Building Code of Australia

Assessment Report

Project: Bungendore Temporary School

Report Number: RE230468.02BCA

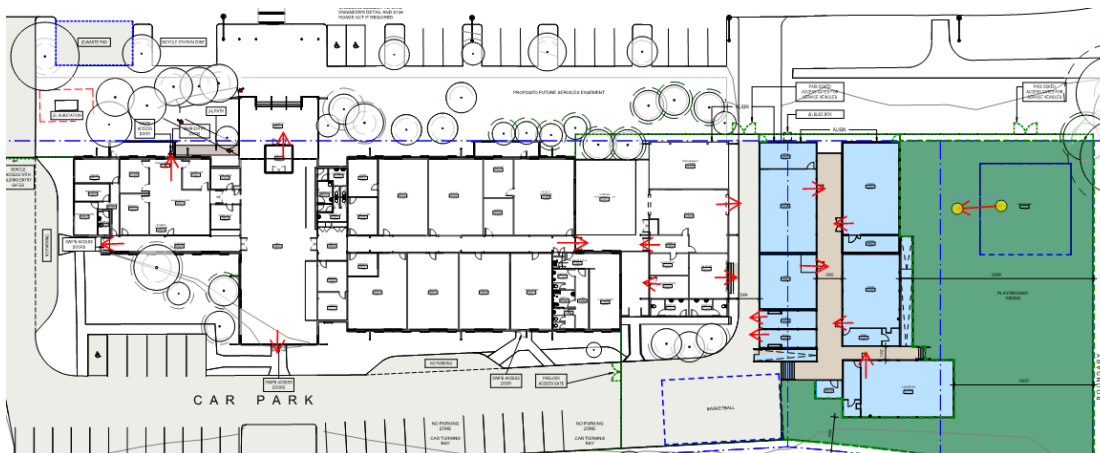
- 4.2. Fire Hazard properties of new internal linings, materials or assemblies used in the building are required to comply with C2D11 and Specification 7 of the BCA.

The fire hazard properties of existing combustible floor linings cannot be determined. However the requirements for school buildings are the same as office buildings, therefore it is not considered necessary that the existing floor finishes be verified for compliance. Existing wall and ceiling linings are typically non-combustible.

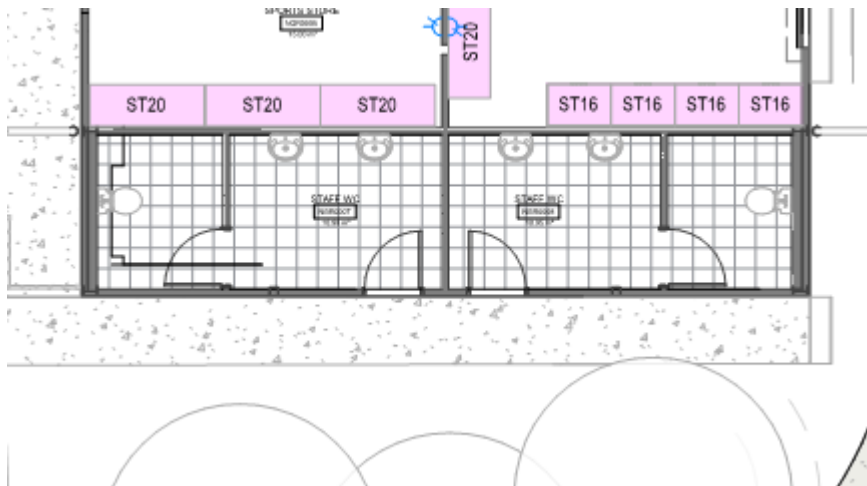
- 7.9 Sanitary facilities are to be provided in accordance with BCA Part F4. The following number of sanitary facilities are required:

The two staff sanitary facilities in existing adjunct building (proposed to be used as performance & storage) are to be signposted as one female and one male facilities.
